LINOTYPE IMPROVEMENT SHEET

NO. 287

JUSTIFICATION ROD (R.H.) STOP STUD (SELF-QUADDER)

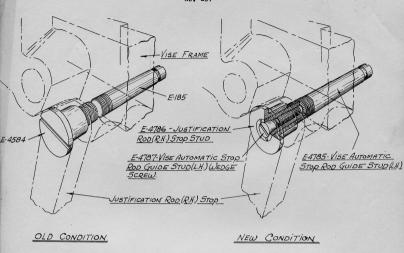
A change has been made in the design of the Justification Rod (R.H.) Stop Stud and Vise Automatic Stop Rod Guide Stud (L.H.) to accommodate the Vise Automatic Stop Rod Guide Stud (L.H.) Medge Sorew.

This is to prevent the Justification Rod (R.H.) Stop Stud from loosening.

Can be applied to Outstanding 30 & 42 $\,$ Bm Machines equipped with Self-Quadder having the Justification Rod (R.H.) Stop by removing E-4584 and E-185 and Adding one each of E-4785, E-4786 and E-4787.
